Project	IEEE 802.16 Broadband Wireless Access Working Group < http://ieee802.org/16 >	
Title	Idle Mode – Location Update Enhancement	
Date Submitted	2004-11-05	
Source(s)	Ronny (Yong-Ho) Kim, and Changjae Lee LG Electronics, Inc. 533, Hogye-1dong, Dongan-gu, Anyang-shi, Kyongki-do, Korea	Voice: +82-31-450-2945 Fax: +82-31-450-7912 mailto: [ronnykim, cjlee16]@lge.com
Re:	Response to Sponsor Ballot	
Abstract	Idle Mode – Location Update Enhancement in 802.16e	
Purpose	Adoption of proposed changes into P802.16e	
Notice	This document has been prepared to assist IEEE 802.16. It is offered as a basis for discussion and is not binding on the contributing individual(s) or organization(s). The material in this document is subject to change in form and content after further study. The contributor(s) reserve(s) the right to add, amend or withdraw material contained herein.	
Release	The contributor grants a free, irrevocable license to the IEEE to incorporate material contained in this contribution, and any modifications thereof, in the creation of an IEEE Standards publication; to copyright in the IEEE's name any IEEE Standards publication even though it may include portions of this contributi

Figure 1. Idle Mode Location Update – Power Down

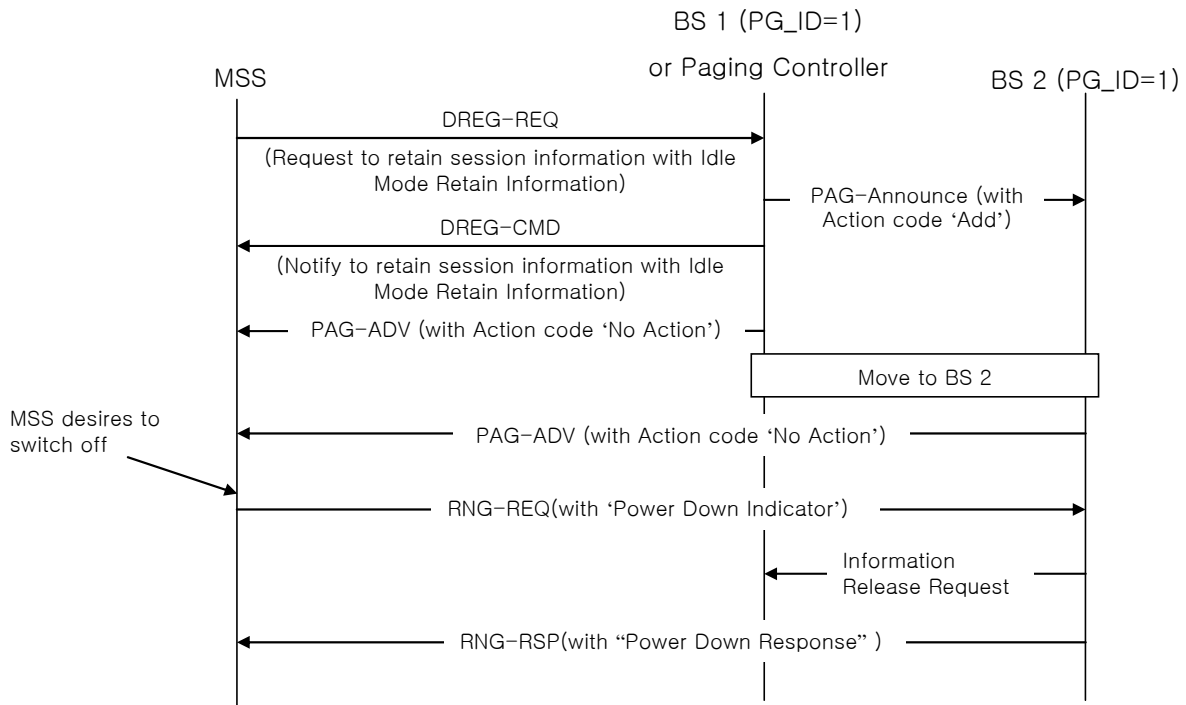
In this contribution, Idle Mode location update enhancement is proposed. When an MSS goes into Idle Mode there is information retained and used for expedited network entry from Idle Mode. Even though an MSS turns off its power while it is in Idle Mode, Idle Mode Retain information would be maintained until BS finds out the MSS is not available anymore. If an MSS can report its status of power off before an MSS turns off its power, information related to the MSS in Idle Mode can be managed more efficiently. Operation is shown below in Fig. 1. This mechanism enables the Paging Controller to detect unavailability without performing unavailability check through repeated unanswered paging messages or through expiration of the Idle Mode System Timer. Benefit of proposed Location Update enhancement is exact and quick status update of MSS in Idle Mode and unnecessary action reduction to detect MSS's unavailability.
